Hampshire
County Council

Enquiries to	Nick Gammer	My reference	6/3/9/263
Direct Line		Your reference	F/23/96631
Date	30 th January 2025	Email	Nick.gammer@hants.gov.uk

Re: One Horton Heath, Internal Distributor Road

Construction of an internal distributor road and associated footways, cycleways, lighting, landscaping and SuDS basins, and diversion of Public Rights of Way footpaths FOHHF 701 and 702 as part of the One Horton Heath development.

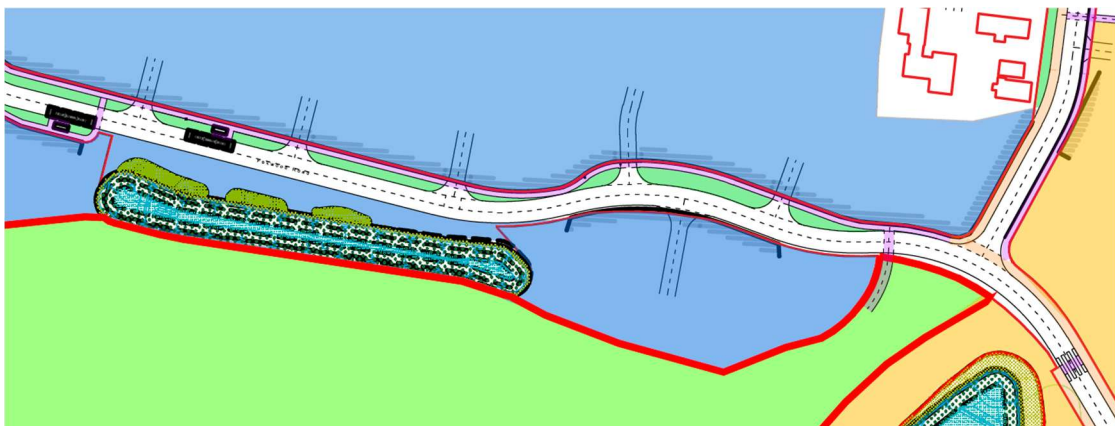
The submitted movement strategy shows a very circuitous route for cycles (dashed green within the extract below), significantly longer than following the spine road (red dashed). There is ample lateral width for the footways to be increased to minimum (3m) shared use width here, providing a connection from the cycle facilities on The Avenue to those shown on Fir Tree Lane. Inclusion of cycle provision on one side of the internal distributor road as a minimum between the link to Fir Tree Lane and Quobleigh Breach Junction with The Avenue is considered necessary to make the proposals acceptable.

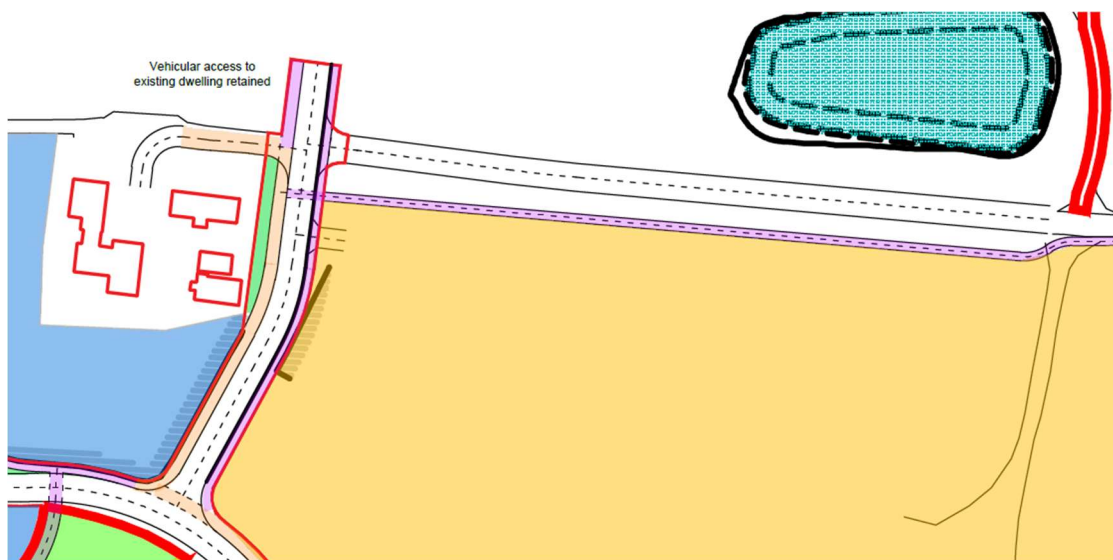
It was previously raised that the east-west link south of, and running parallel to, Fir Tree Lane (north of the local centre) should be shared use, not pedestrian only, from the point it diverges from the carriageway and routes behind the existing hedge/ tree line. This is relevant as the crossing on the link between the internal distributor road and Fir Tree Lane (which is within the application red line) should be able to accommodate cycles. Alternatively, it may be preferable to move the north-south shared use provision to the eastern side of the Fir Tree Lane link to allow easier access to the local centre and school by cycle. The applicant has noted this and states it will be addressed in the Reserved Matters planning application for the Local Centre. This is acceptable, however, this link is still shown as a footpath and the crossing (which is within this application) is shown as pedestrians only. The plans should be updated to make it clear the crossing, and onward route, can accommodate cycles.

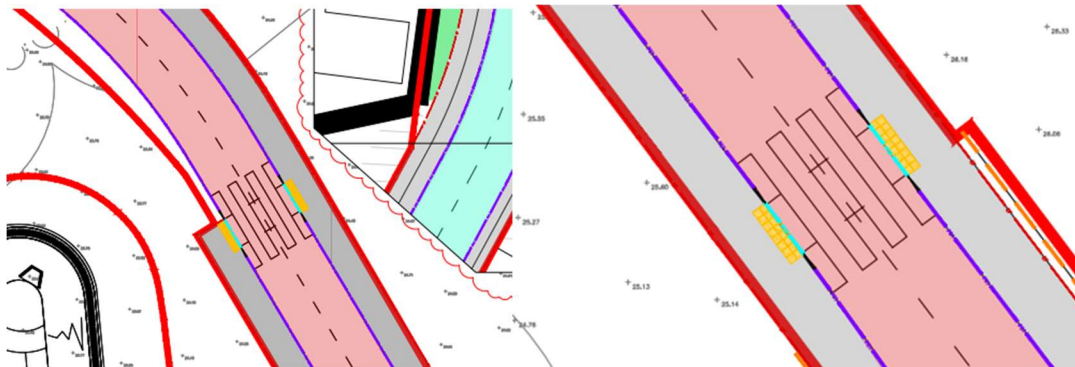
The latest drawings show two crossing points between the link to Fir Tree Lane and Quobleigh Breach Junction with The Avenue; one at the proposed bus stops within The Holme parcel and one near the link to Fir Tree Lane. It is the HA's view that at least one additional crossing point should be provided between the bus stops and Quobleigh Breach junction. While the PCSR states a crossing has been added, and it does appear on Surfacing and Kerbing Layout Sheet 11, this does not appear on any other drawings. This should be included on all drawings submitted for approval.

Route to Fir Tree Lane Capacity

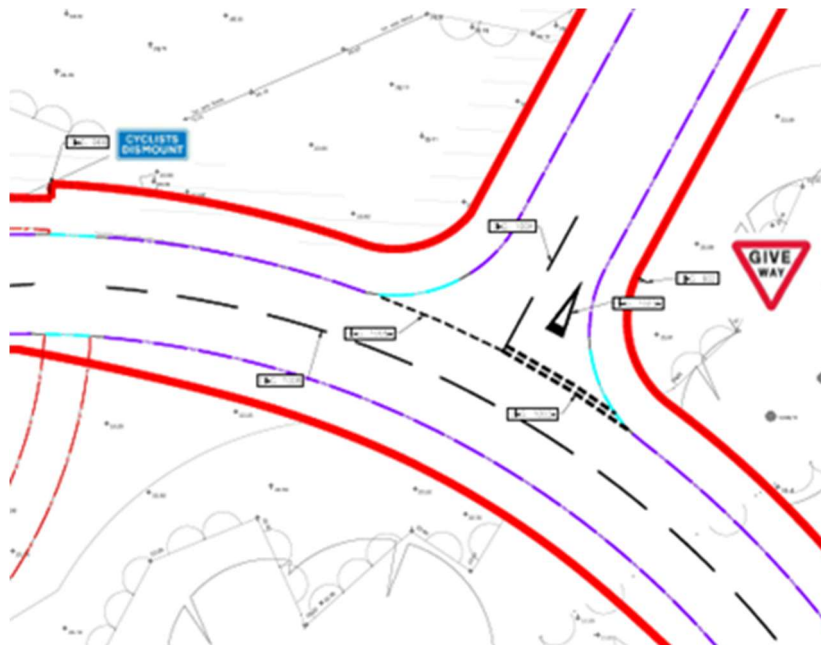
The capacity of the junction of the internal distributor road and the link north to the existing Fir Tree Lane has not been assessed. Under the current outline proposals, this is a through route, as well as an access/ egress for future residents and the nearest access to local centre amenities, the sports pitches and the school. It was previously requested that the forecast traffic flows at this junction are presented and the capacity of this junction modelled. Regarding this request, the PCSR states:
